**Responses to NRC Questions on WCAP-8859 (Non-Proprietary)  
and WCAP-8860 (Non-Proprietary)**

NS-CE-1694

February 13, 1978

Mr. John F. Stolz, Chief  
Light Water Reactors Branch  
Division of Projects Management  
Office of Nuclear Reactor Regulation  
U.S. Nuclear Regulatory Commission  
Washington, D.C. 20555

Figure 3

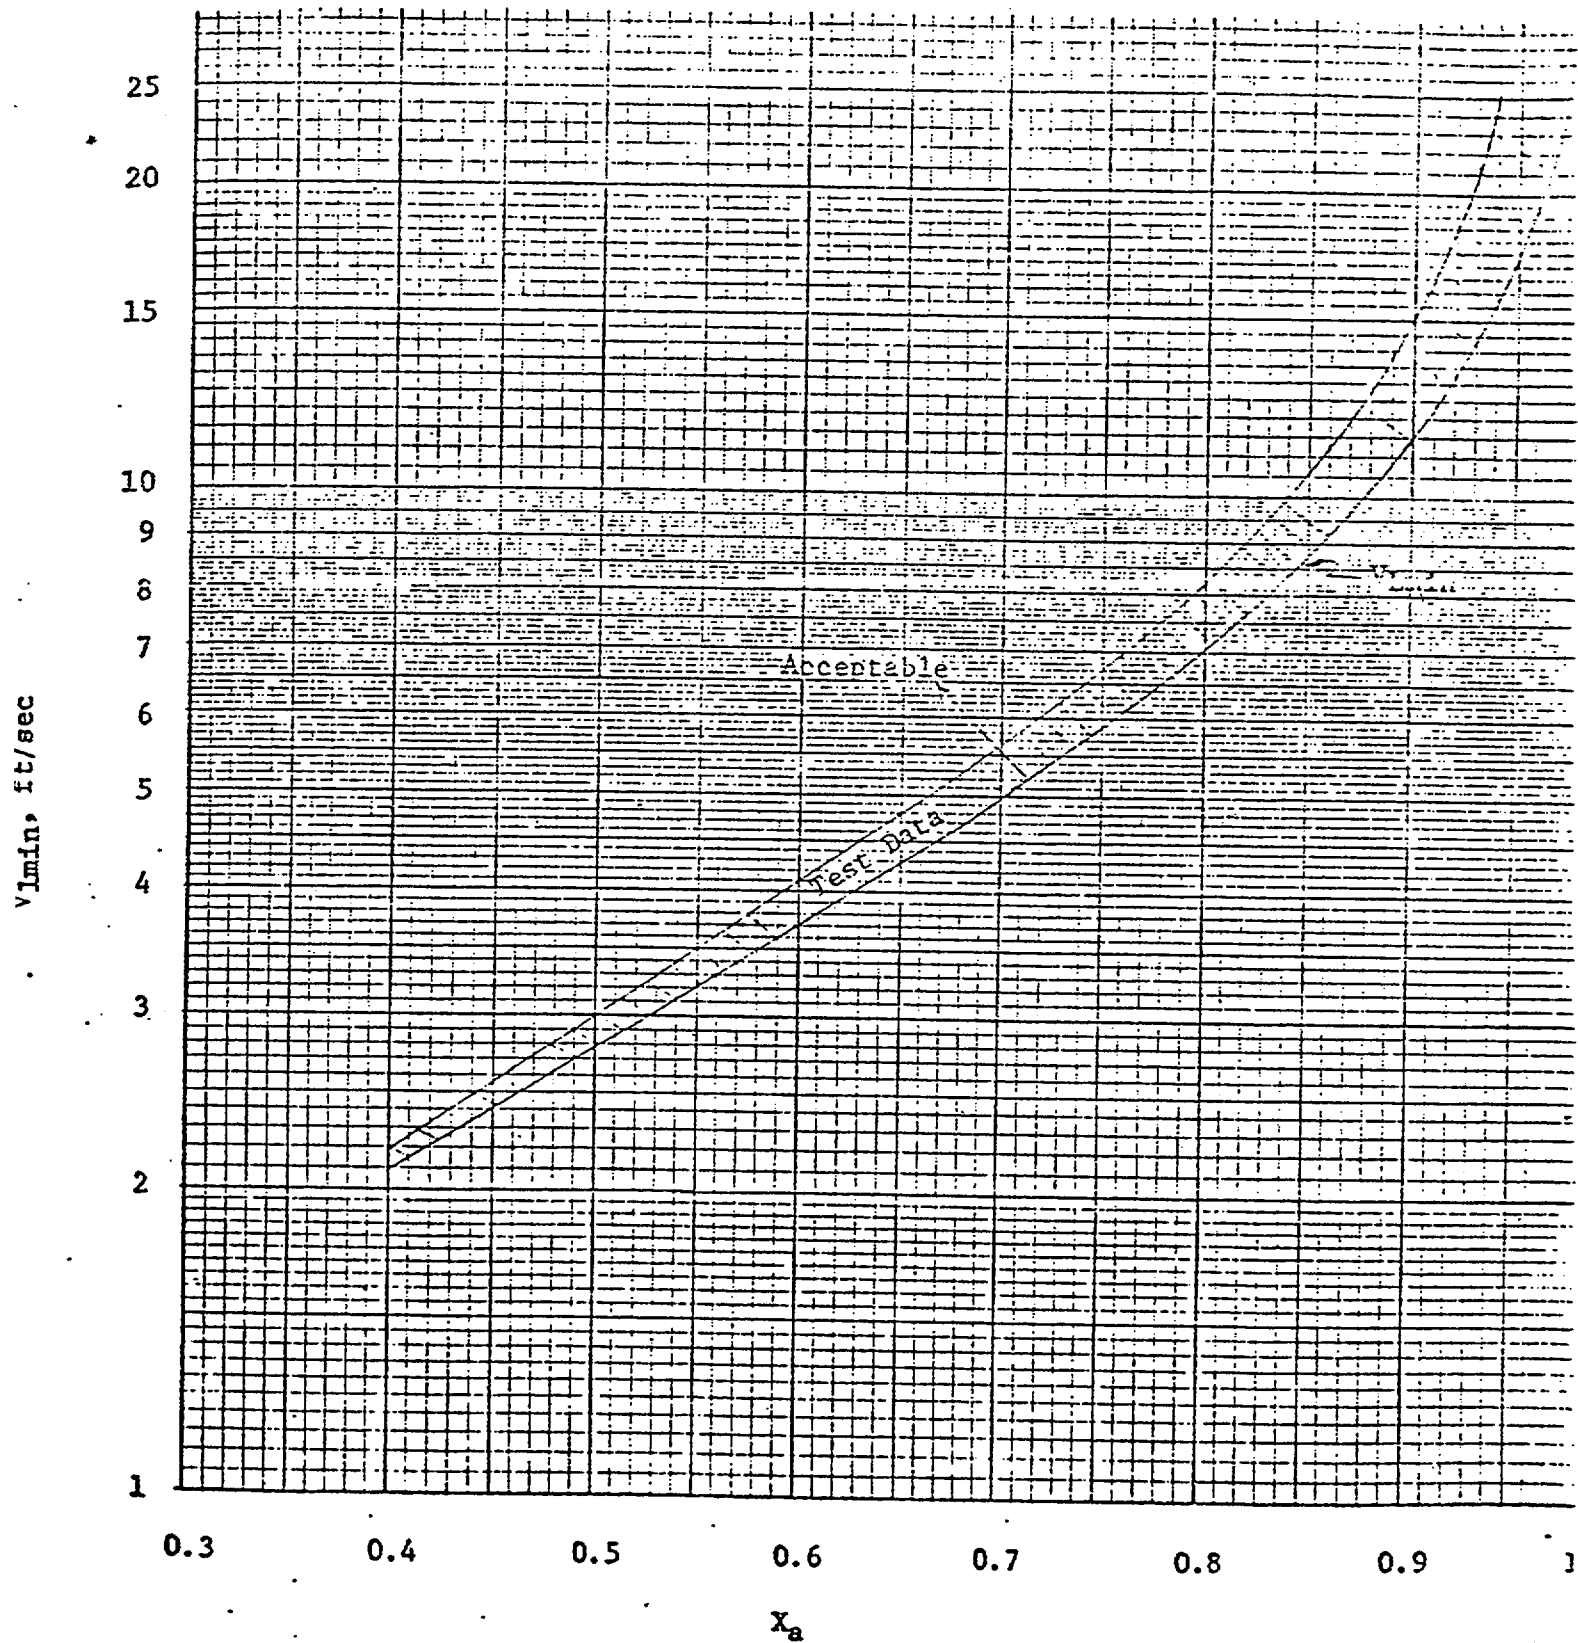
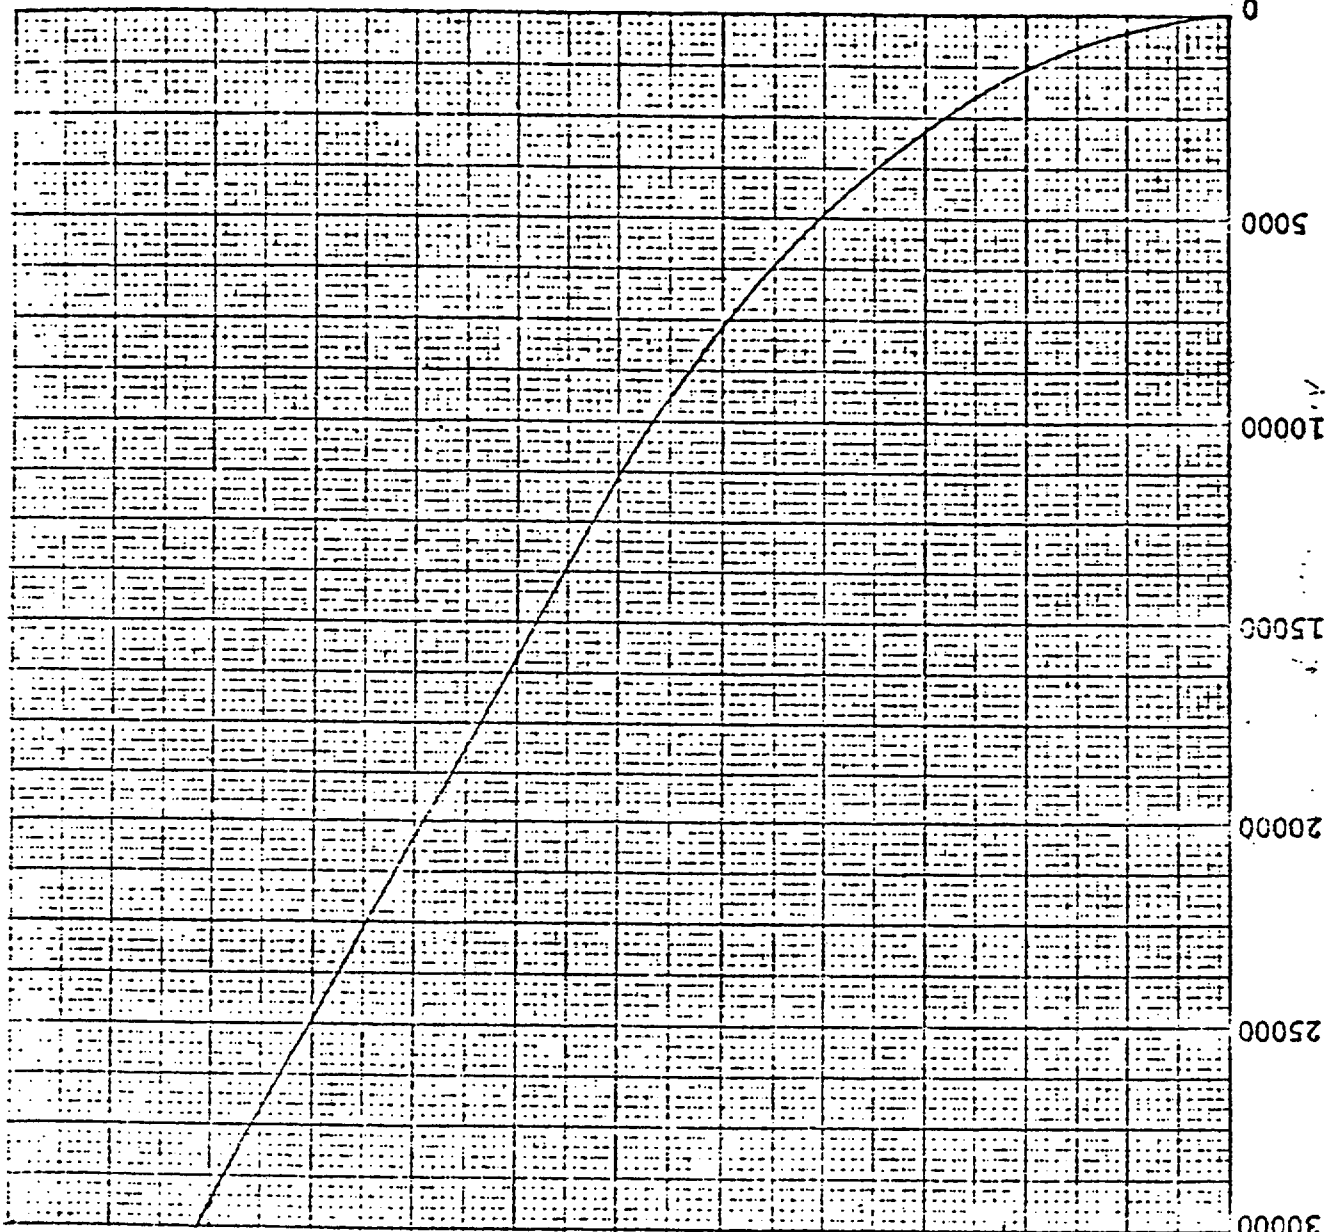
The sensitivity study presented in Figures 5.3.2-1a, b and c indicates that the quality leaving the break is relatively insensitive to assumed values of swirl vane separation efficiency. These results do not appear to be consistent with the comparisons presented in Figures 5.3.2-6, 7 and 8, which exhibit a large sensitivity to swirl vane efficiency predicted by the Steady State Experimental Model. Discuss the reasons for this apparent inconsistency. Provide the empirical correlations discussed on page 5-46 used to generate the comparison with the computer model and discuss the differences between these correlations and the TRANFLO correlation presented on page 4-20. Discuss which empirical correlation was used for each comparison.

$$\begin{aligned}V_{1\text{min}} &= \exp (-1.63506342 \times 10^1 + 1.38683516 \times 10^2 (x_a) \\ &\quad - 4.53364597 \times 10^2 (x_a)^2 + 7.42282031 \times 10^2 (x_a)^3 \\ &\quad - 5.97630475 \times 10^2 (x_a)^4 + 1.89936449 \times 10^2 (x_a)^5), \\ &\quad \text{plotted on Figure 3.}\end{aligned}$$

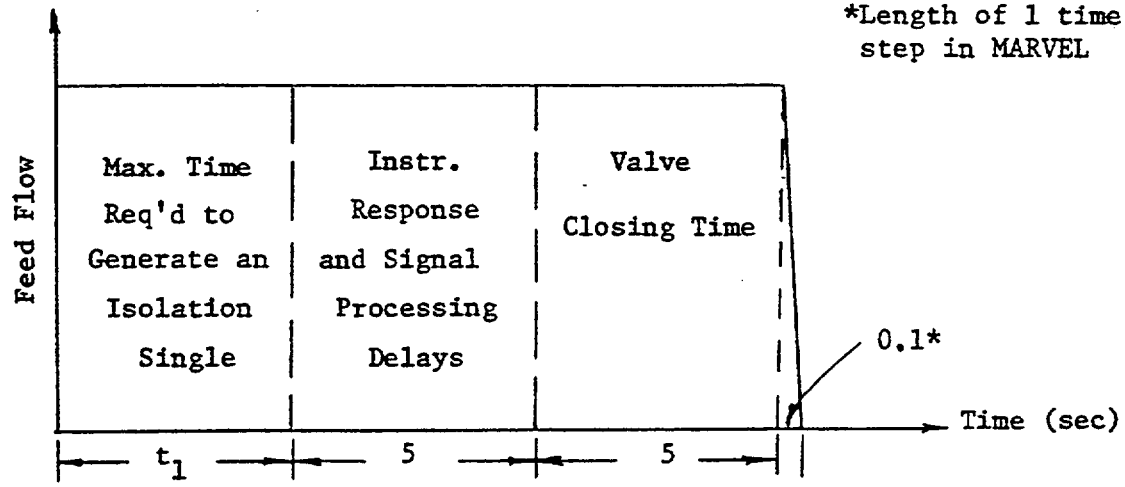
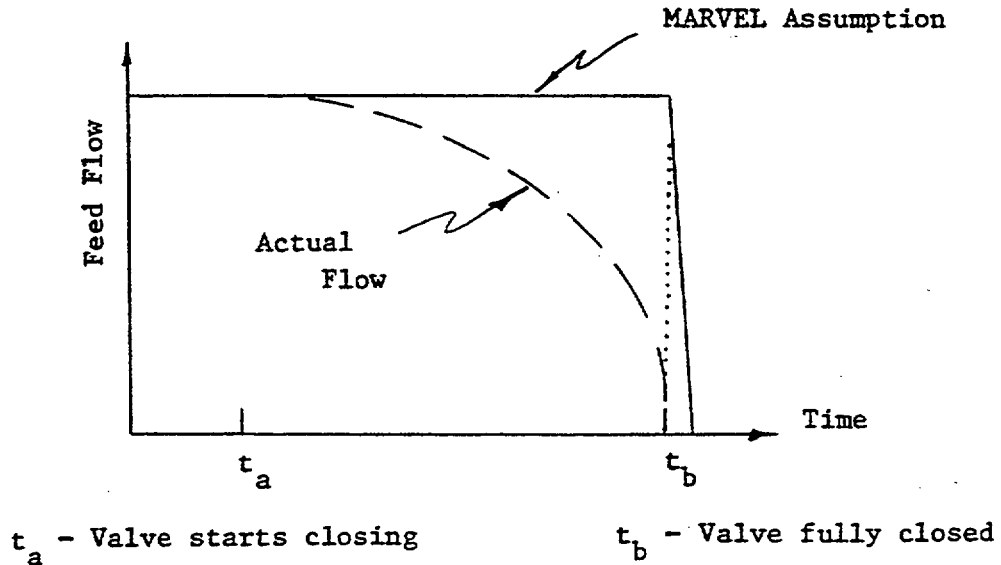
Provide additional details of how the main feedwater flow to the ruptured steam generator is calculated before isolation. Discuss how the trip times given on page 4-20 and the five-second isolation time given on page 3-12 are used to calculate the feedwater isolation times given on page 3-16. Discuss how the feedwater isolation setpoints and isolation times in the tables of Part IV of Appendix A were determined. For each break provide the total amount of main feedwater assumed to flow to the ruptured steam generator. Discuss the methods by which applicants should calculate containment mass and energy release data in the event that feedwater flow exceeds the amounts assumed by the MARVEL code.

The time during which main feed is supplied to the steam generators in the MARVEL analyses for each of the doubled ended ruptures is also given on Page 3-16. The flow was held constant at the specified value for this entire time period. The series of factors which make up each of these times are defined in the sketch below.

The values chosen for each of the factors are conservative for several reasons. Functional design requirements for protection instrumentation and process equipment, for example, require that response and processing delays be much less than 5 seconds. as is conservatively used in these analyses. In general, these times on the order of 0.5 - 1.5

seconds depending upon which protection signal is considered. Also, though design requirements for isolation valves specify a maximum of 5 seconds for closure following a trip signal, closing times are often much shorter, and the flow versus time (during closing) follows a trend much like that shown below rather than the step change in flow used in the MARVEL analyses.
